SERVICE INFORMATION LETTER NO.0153

DATE: February 15, 2002

1. SUBJECT: Tail Rotor Assembly, P/N 28-150000, Configurations
2. MODEL: F-28C, 280C, F-28F, 280F, and 280FX
3. EFFECTIVITY: All serial numbers
4. BACKGROUND:

Figure 1. Tail Rotor Assembly, P/N 28-150000-7, & -9

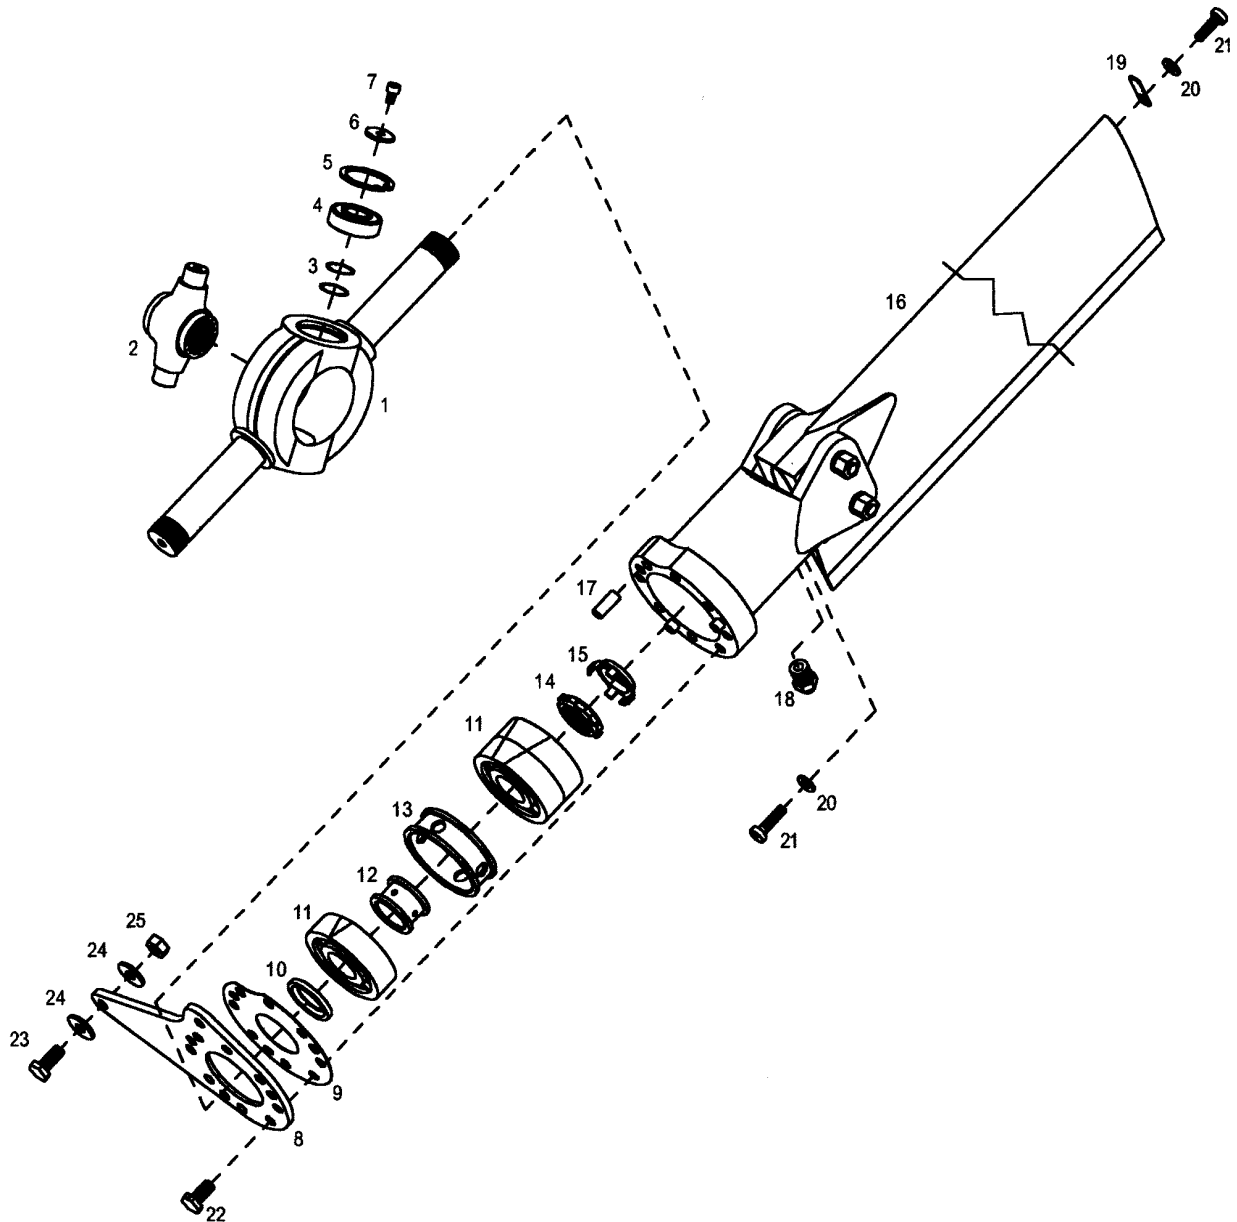
One of the problems with the 28-150000-7 and -9 tail rotor assemblies is excessive wear on the inboard thrust bearing of the ECD035-11 bearing set. A complete ECD035-11 bearing set must be installed when the inboard thrust bearing is replaced even though the outboard thrust bearings are normally in serviceable condition. Modification of the 28-150000-7 or -9 tail rotor assembly to a 28-150000-10 tail rotor assembly improves serviceability and significantly reduces the cost of maintaining the tail rotor assembly.

5-1. MODIFICATION:**A. 28-150000-7 and -9 DISASSEMBLY: (Refer to Figure 1)****NOTE**

3. Remove the lock wire from the bolts (22) in the retention plate (8) and remove the bolts.
4. Remove the grease fitting (18) from the blade grip and loosen the nuts on the bolts securing the tail rotor blade in the blade grip.

5. Using a heat gun, heat the blade grip to approximately 250EF/121EC.
6. Remove the blade and grip assembly (16) by pulling on the blade with one hand and tapping on the blade bolt nuts with a nylon hammer.
7. Remove the lock washer (15) by prying up on the tabs with a screw driver.
8. Remove the nut (14) from the spindle using tool T-0056.

9. Remove the outboard thrust bearings (11) from the spindle.
 10. Remove the spacers (12 & 13) from the spindle.
 11. Remove the inboard thrust bearing (11) from the spindle.
 12. Remove the retention plates (8 & 9) (-7 assembly only) from the spindle.
 13. Remove the spacer (10) from the spindle.
 14. Rotate the tail rotor assembly in the vise and disassemble the opposite side of the tail rotor assembly.
- B. 28-150000-10 ASSEMBLY: (Refer to Figure 2)

This Service Information Letter (SIL) provides instructions for changing the tail rotor assembly to a 28-150000-10 configuration and current part number information for the 28-150000-7, -9, and -10 tail rotor assemblies.

Use the procedure in paragraph 5-1 to modify the tail rotor assembly from a -7 or -9 configuration to a -10 configuration.
